RE: Proposed Revisions to ENERGY STAR[®] Program Requirements

Cardinal Glass Industries appreciates the opportunity to provide additional comments and suggestions related to the most recent proposed revisions to the ENERGY STAR[®] Program for fenestration products as presented in the Windows, Doors, and Skylights Draft Criteria and Analysis, dated August 6 2008.

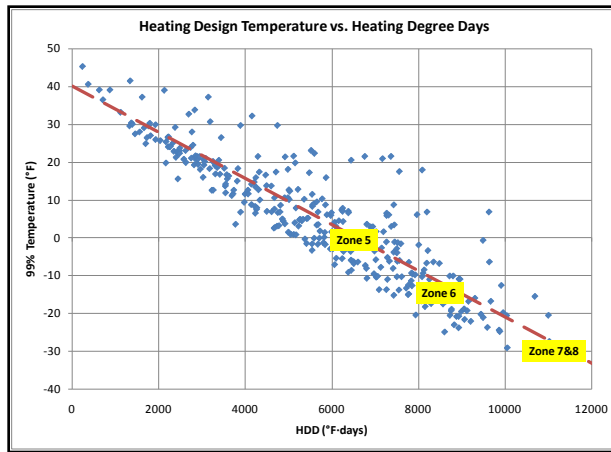
The thermostat settings used by ENERGY STAR® are not consistent with the IECC or data published in RECS. As an example, IECC doesn't show any thermostat setback, RECS suggests that only 23% of residences use a setback thermostat, and ENERGY STAR® presumes that all homeowners utilize a 5°F night setback. The setpoint differences are tabulated below. The lower cooling setpoints from RECS and the 2009 IECC have the potential to significantly alter the slope of the trade-off lines in the north (bias towards less solar benefit).

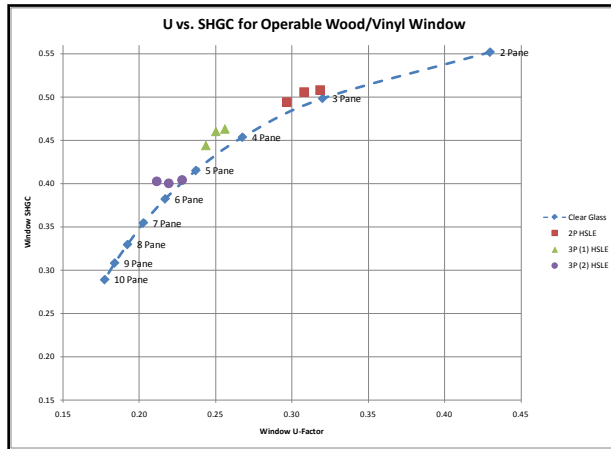
As U-Factors are lowered, the extra glass layers and/or low-E coatings added to the structure will reduce the maximum solar gain of the window. The chart below shows that high solar gain low-E coatings (3 variants modeled) can displace layers of clear glass, but it's difficult to get above the basic profile shown.

The published phase 2 criteria show ES4/ES5 trade-offs starting at SHGC=0.55 with U-Factors less 0.28. The only products that can reach that are fixed windows with narrow frame profiles.

For ES5 to fit the comfort mantra, the trade-off point should be around U=0.25 and SHGC=0.35 with a sloped line down and to the left that fits a revised orientation/thermostat/shade usage analysis. Note that SHGC values greater than 0.35 can be allowed but that U shouldn't drift to the right.
